ENCLOSURE 1
FINAL MARK-UPS FOR CHAPTER 8 AND CONFORMING CHANGES FOR FSAR REVISION

Figure 8.3-3—Normal Power Supply System Single Line Drawing
Sheet 1 of 5

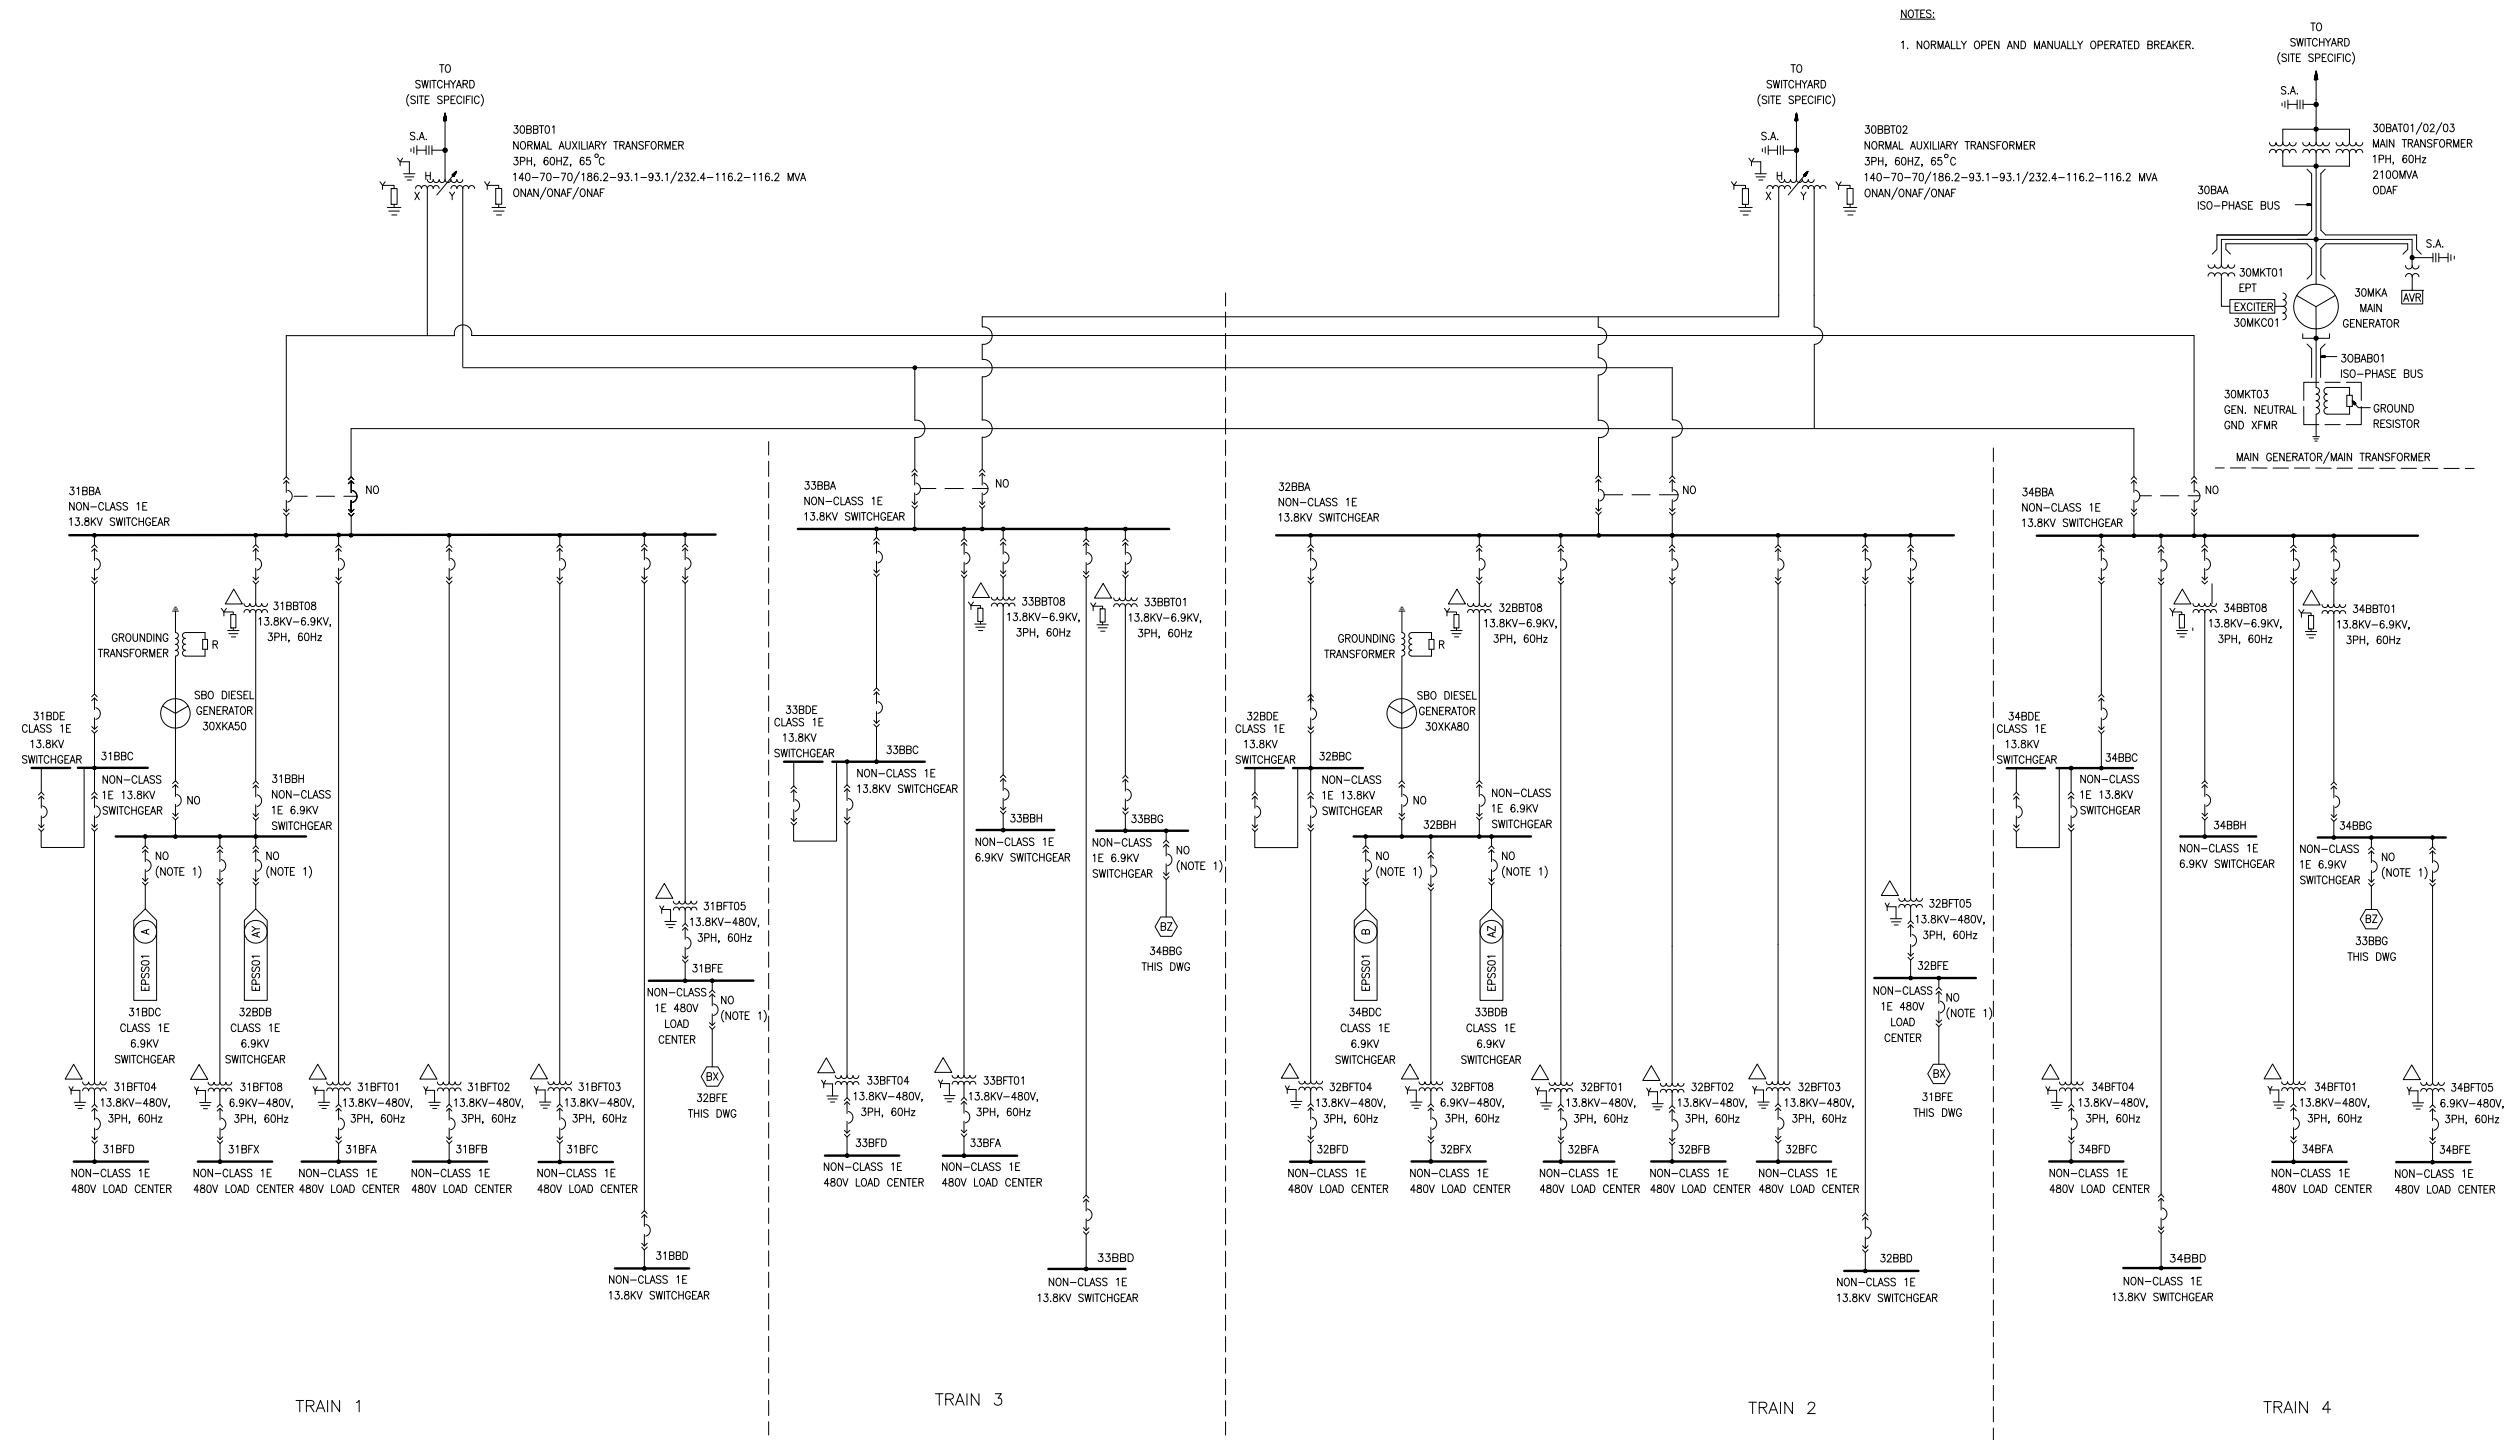
Description of Change	Pages Affected
Figure 8.3-3 (sheet 1 of 5): The cross-tie breakers between the 33BBG bus and 34BBG buses should have a "NO" as the SDD Section 4.1 (15-9028406-004) states that these are normally open.	Page 8.3-130 > Figure 8.3-3
Figure 8.3-3 (sheet 2 of 5): The cross-tie breaker between 31BFE and 32BFE should have a "NO" as the SDD Section 4.1 (15-9028406-004) states that these are normally open.	Page 8.3-131 > Figure 8.3-3
Figure 8.3-3 (sheet 3 of 5): The cross-tie breaker between 31BFE and 32BFE should have a "NO" as the SDD Section 4.1 (15-9028406-004) states that these are normally open.	Page 8.3-132 > Figure 8.3-3
Figure 8.3-3 (sheet 4 of 5): The cross-tie breaker between the 33BBG bus and 34BBG buses should have a "NO" as the SDD Section 4.1 (15-9028406-004) states that these are normally open.	Page 8.3-133 > Figure 8.3-3
Figure 8.3-3 (sheet 5 of 5): The cross-tie breaker between the 33BBG bus and 34BBG buses should have a "NO" as the SDD Section 4.1 (15-9028406-004) states that these are normally open.	Page 8.3-134 > Figure 8.3-3
